Subject: Byron Generating Station Units 1 and 2
Independent Design Inspection
NRC Inspection Report Nos. 50-454/83-32
NRC Docket Nos. 50-454 and 50-455

BYRON IDI RESPONSES

Response to NRC Letter Dated March 23, 1984

M-91G-12-(C)-REV.3-(±3 TOL.)

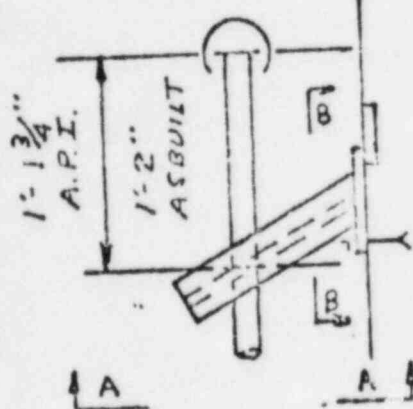
1. FCR F-9079
2. The backup calculation
3. Revision C to Support Drawing 1AF03009R"

Byron FCR F-9079 (dated 4-16-81) was written against Revision B of support drawing 1AF03009R to have a 1/4-inch overlap on its embedded plate. This FCR was picked up on Revision C of the drawing and issued on 12-23-81. Subsequently, this FCR was closed out on 1-9-82 as shown on Part D of the first page of the FCR.

FIGURE F4.1-1

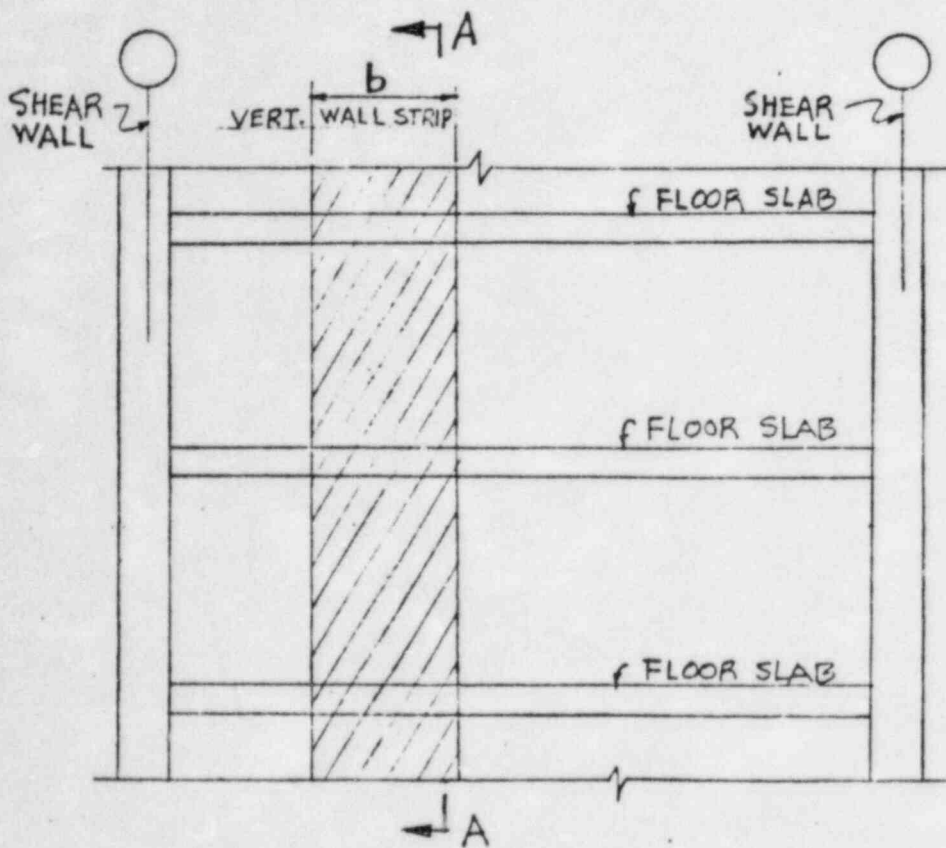
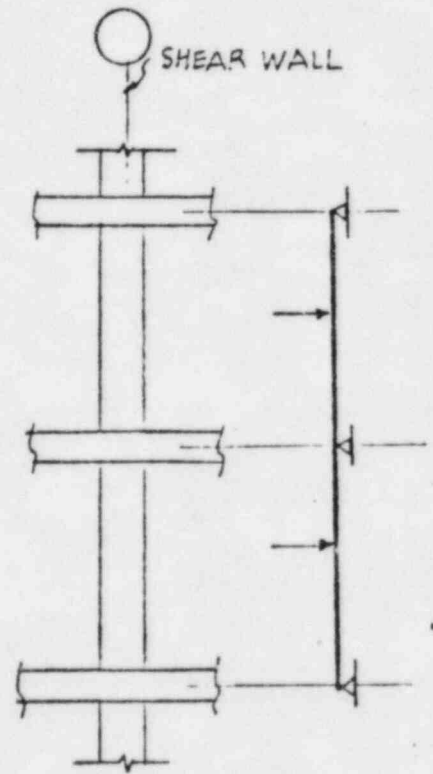
For a given wall loaded with a transverse wind load, describe how the transverse load at the center of a wall between two supporting orthogonal walls (shear walls) is carried out through the wall to the orthogonal walls which carry the shear force as in-plane shear in a normal shear wall concept. Describe how Sargent & Lundy determined the load capacity of the peripheral wall loaded transversely and converted these forces to stresses and then to reinforcing areas, if required. Describe how these same loads are addressed in the final load check. The use of diagrams to illustrate the details is recommended."

The transverse flexural steel area required for each wall strip was calculated using the flexural strength provisions of Chapter 10 of ACI 318-71. The transverse shear friction steel area required was calculated using the shear-friction provisions of Chapter 11 of ACI 318-71. Transverse loads are addressed in a similar manner in the final load check.

FIGURE U4.2-1*

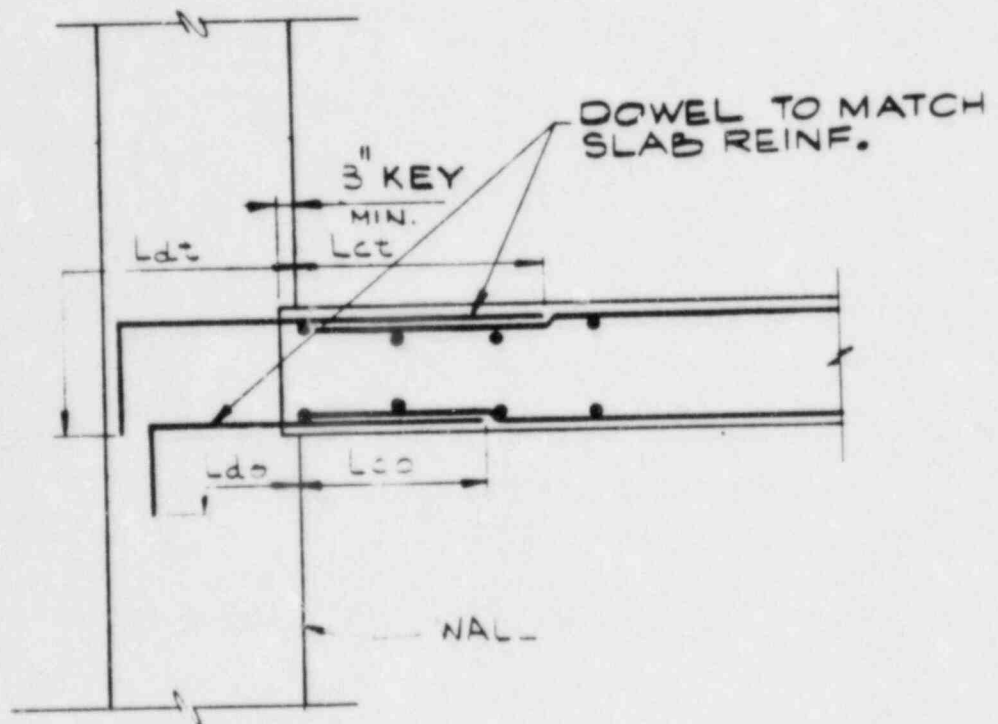
"The design procedure outlined in the response, if applied for all slab designs on the Byron project, would yield conservative steel areas (bottom steel) for midspan positive moments. You are requested to indicate whether this concept was used throughout the plant. Indicate if the procedure described in the original answer for supplying negative steel (top steel) at each slab boundary was used throughout the project and if so what portion of the maximum moment for a simply supported case was provided in negative moment capacity at the boundaries. Indicate, by providing detailed references to written documents, how these project-wide concepts (if used) were provided to individual designers in the way of instructions or procedures. If no project-wide concept was applied, indicate what technique was used in providing slab reinforcing based on varying boundary conditions."

As noted in our original response, negative moment steel equal to that at the continuous support was provided at the junction to the wall of slab 4AB53. This is a conservative design approach which was used for all slabs supported by walls. This typical detailing is shown as Slab Support Types 5 and 6 (see Figures U4.2-1 and U4.2-2) on Structural Drawing S-473 which was included in project Specification F/L 2722 and initially released to the appropriate contractors on August 7, 1974.

These standard details are specified for construction at all slab-to-wall junctions and, because they are standard details, no other reinforcing arrangements could have been used. Thus, their use is a project-wide concept and did not depend on the judgment of the individual designer involved.
